Work Order ID 99862

Item Name: Crosstube Aft

DRAWING NO. D206-667-243	TITLE CROSSTUBE ASS'Y (206L HIGH AFT)	REV. C	DART AEROSPACE LTD ENGINEERING ORDER		D.E.O. NO. D206-667-243-C-1	SHEET NO. SHEET 1 OF 1	SCALE NTS
DRAWN 97	CHECKED ASS	MFG. APPR. RB	APPROVED MP	DE APPR. #			
DATE 11.07.15	DATE 11.07.20	DATE 11.07.21	DATE 11/07/21	DATE 11.07.21

DESIGN	99	DART AEROSPACE LTD
DRAWN	RF	HAWKESBURY, ONTARIO, CANADA
CHECKED	CP	DRAWING NO. D206-667-243
MFG. APPR.	EP	REV. C SHEET 3 OF 4
APPROVED	TH	TITLE SCALE
DE APPR.	TH	CROSSTUBE ASS'Y (206L HIGH AFT) NTS
DATE	08.11.06	COPYRIGHT © 2000 BY DART AEROSPACE LTD

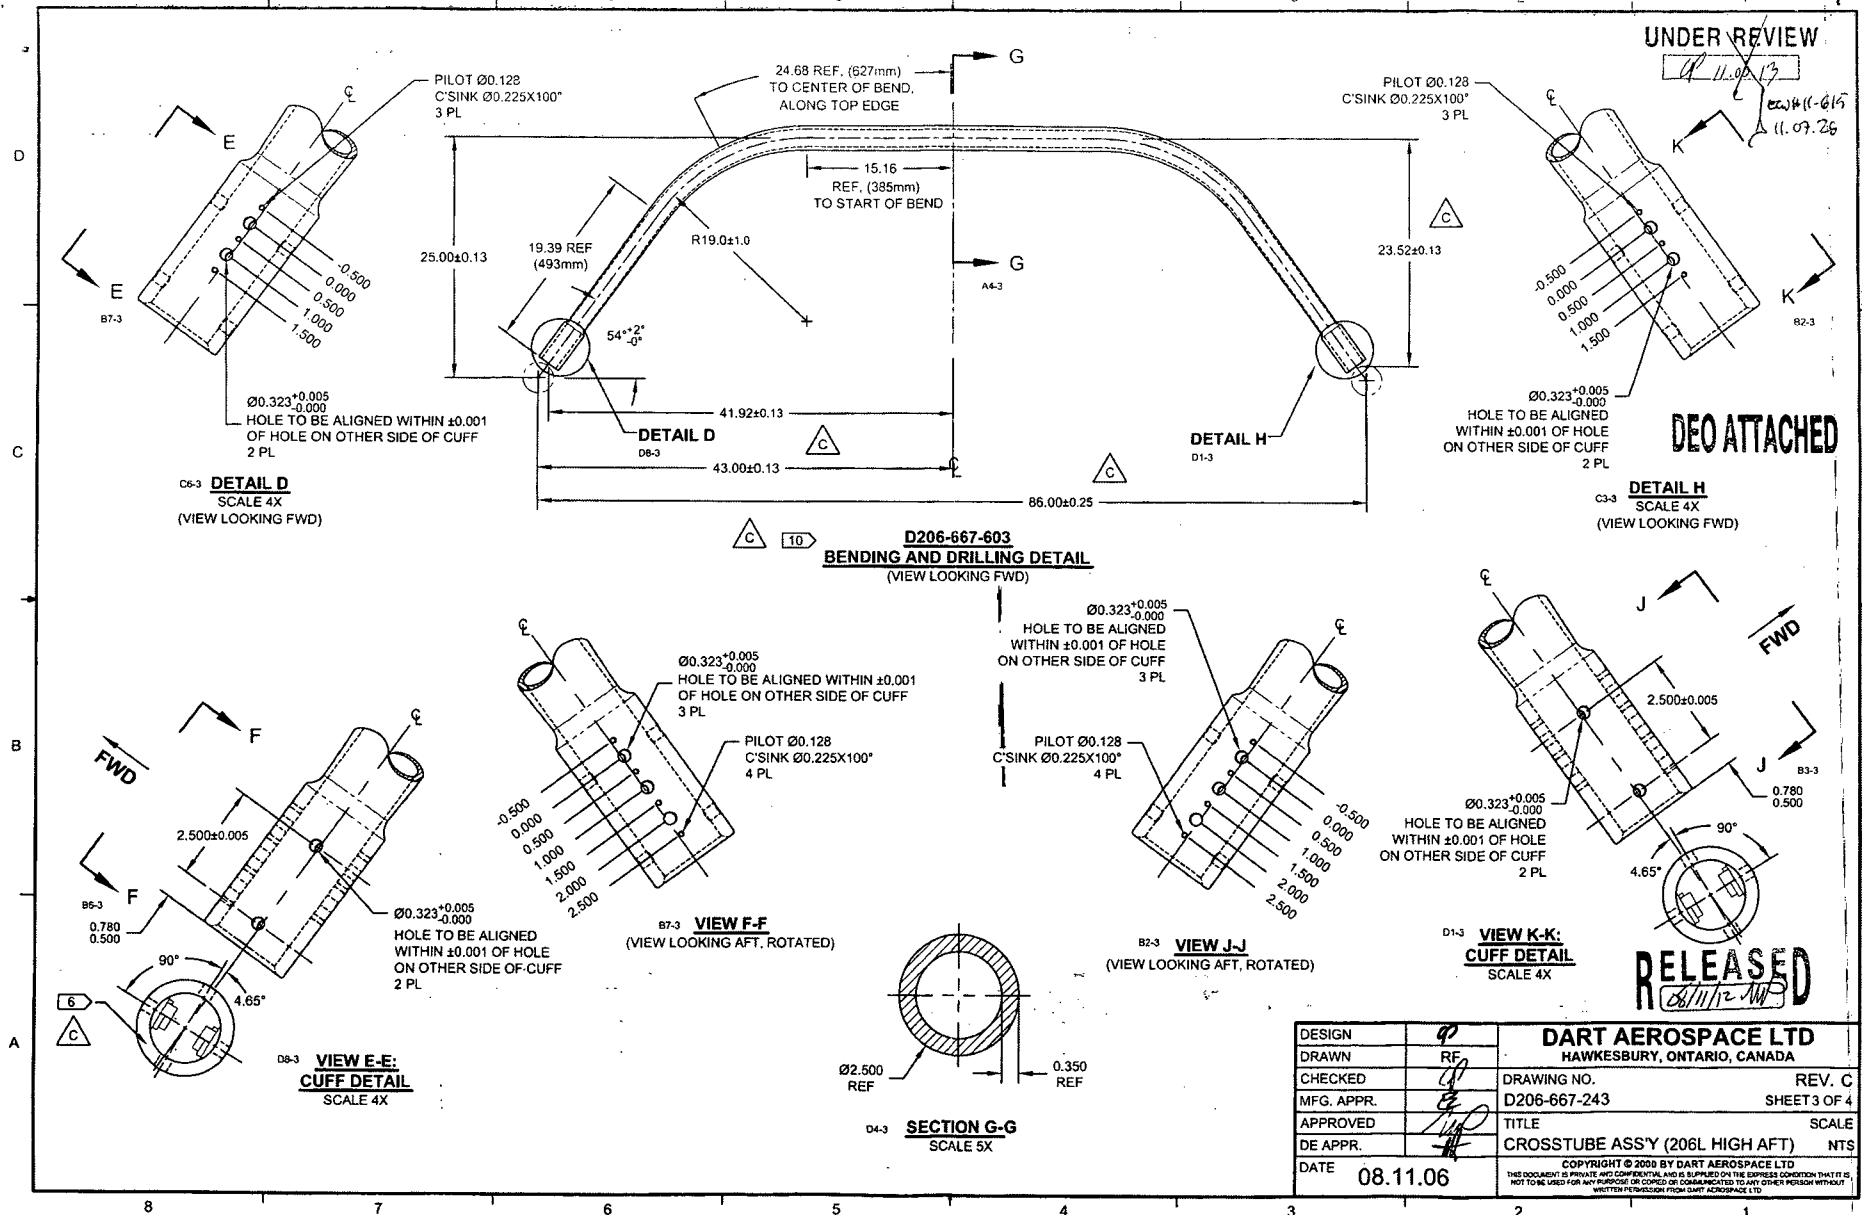
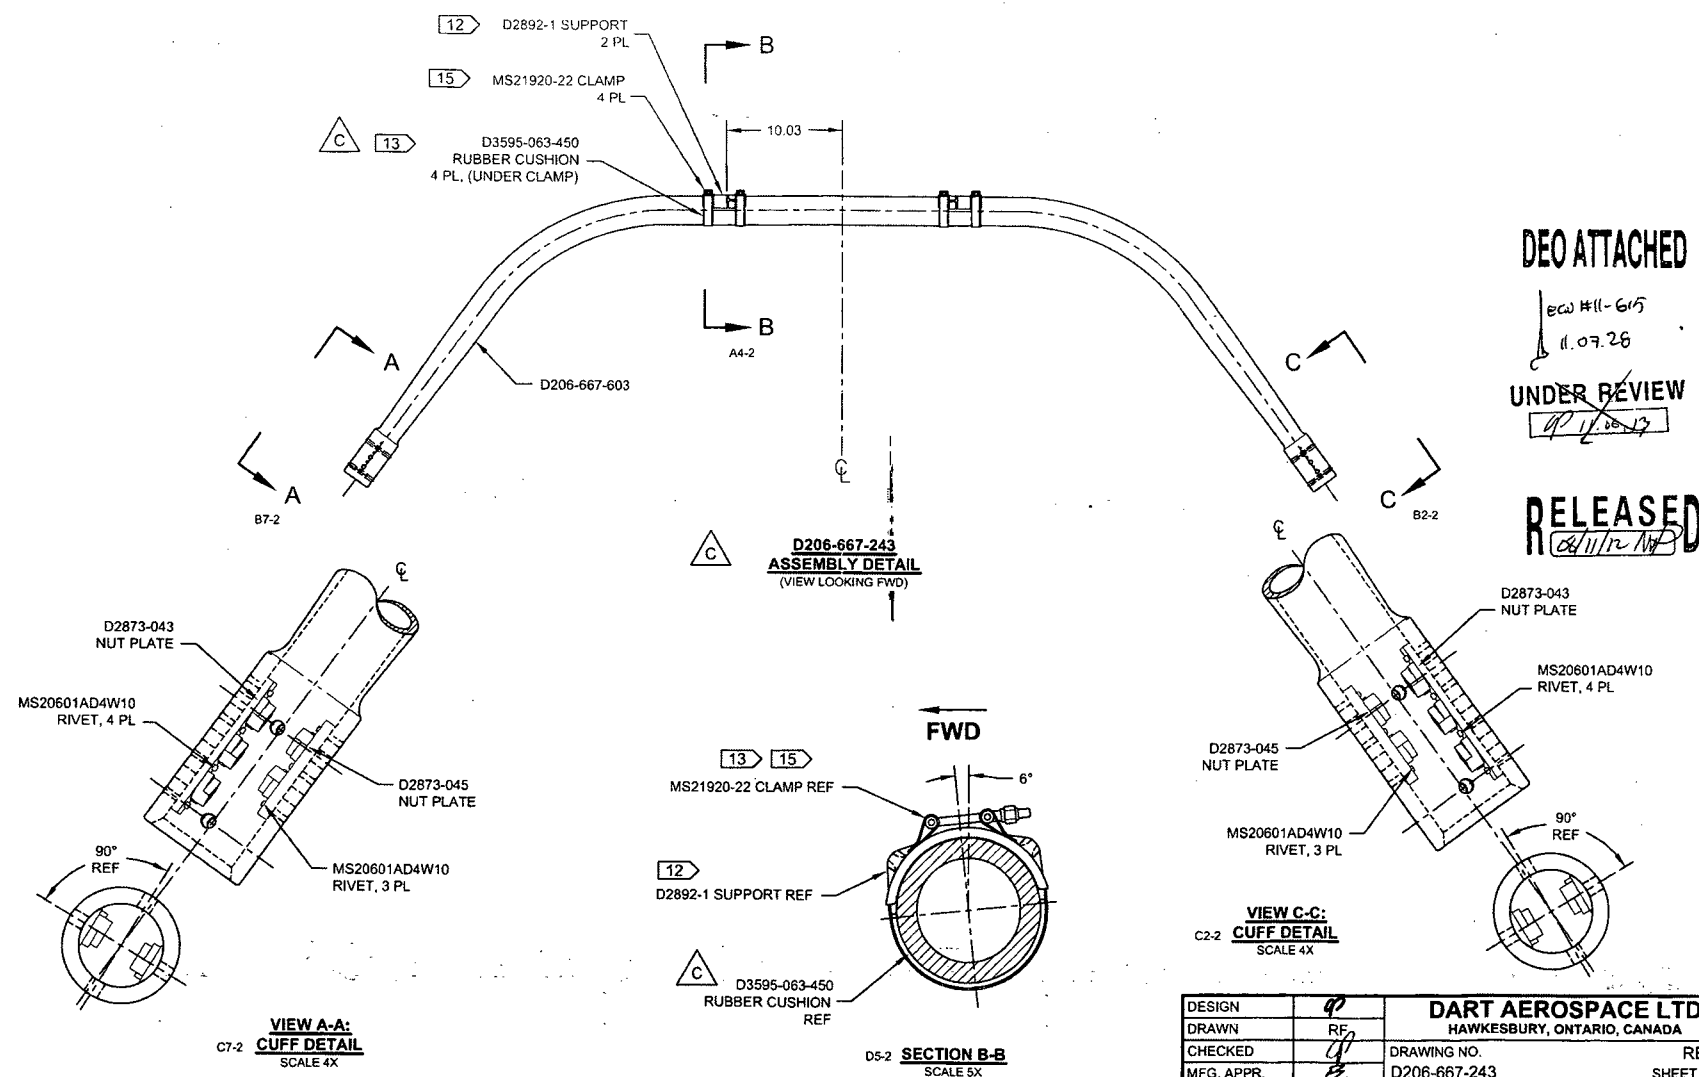
REPLACE MAGNOBOND WITH PROSEAL.

NOTE 12 & 15, SHEET 1 IS AMENDED AS FOLLOWS:

- 12) TO INSTALL D2892-1 SUPPORT: ABRASE MATING SURFACE OF SUPPORT AND CROSSTUBE WITH 180-GRIT SANDPAPER AND REMOVE RESIDUE WITH MEK (OR EQUIVALENT). APPLY A 0.04" TO 0.07" THICK LAYER OF PROSEAL 890 CLASS B-2 (OR AMS-S-8802 CLASS B-2) SEALANT TO MATING SURFACE OF SUPPORT.
- 15) TORQUE CLAMPS 80 TO 100 IN-LB. ENSURE AT LEAST 1.5 THREADS SHOWING IN SAFETY AND THAT NUT HAS NOT BOTTOMED-OUT AFTER TORQUING. **PRIOR TO PACKAGING, RE-CHECK TORQUE ON CLAMPS AFTER PROSEAL 890 SEALANT HAS CURED FOR 72 HOURS.**
